Service Letter No. 352

SUBJECT: Modification of Windshield Defroster System

MODELS AFFECTED: PA-24, PA-24-250 Comanches, Serial Nos. 24-2299 to 24-2338, 24-2340, 24-2341, 24-2342, 24-2344 to 24-2360 inclusive, 24-2363 to 24-2369 inclusive, 24-2371 to 24-2379 inclusive, 24-2381, 24-2383 to 24-2396 inclusive, 24-2398, 24-2399, 24-2400, 24-2402, 24-2405, 24-2406, 24-2409, 24-2411 and 24-2412.

SERVICE LETTER NO 352

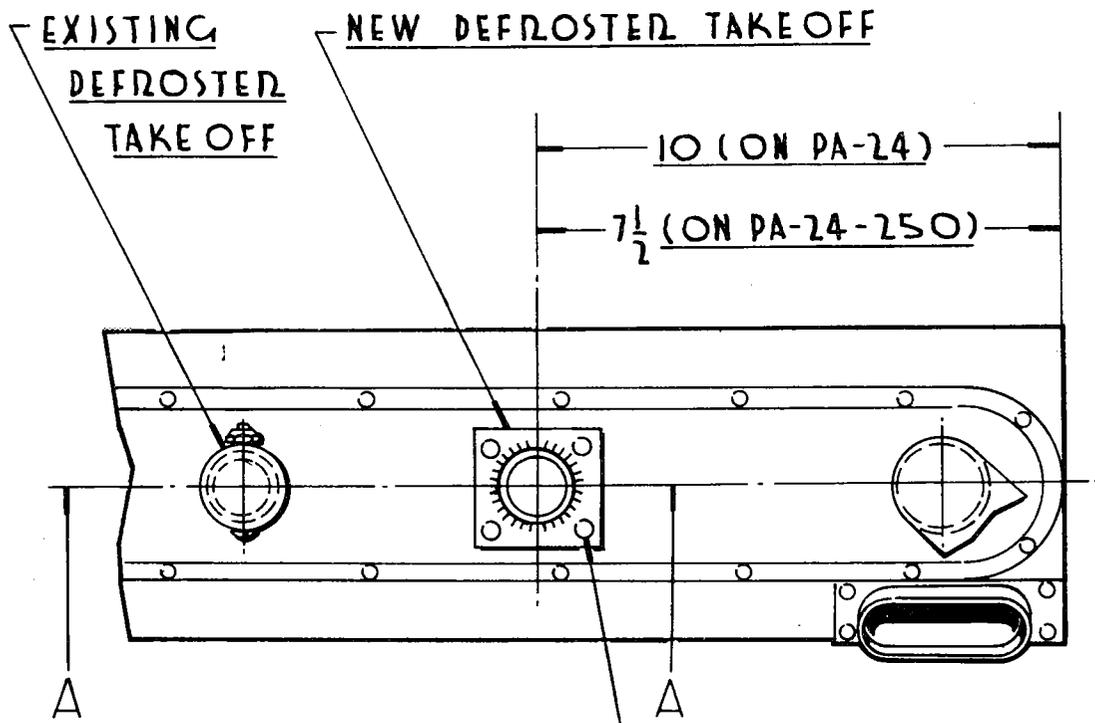
The defroster system as installed on the subject airplanes is capable of delivering hot air to the windshield at a temperature high enough to distort the windshield glass if used on a warm day.

The modification of these defroster systems may be accomplished by referring to the sketch on the reverse side of this Service Letter.

PDR134A-6 RIVET
4 REQ.

1 1/4 HOLE (IN DUCT + HOUSING)
(USE EXTREME CAUTION TO
AVOID PUNCTURE OF MUFFLER)

.166 HOLE (THRU)
AN515-8228 MACH. SCR.
AN364-832 S.L. NUT

SECTION A-A
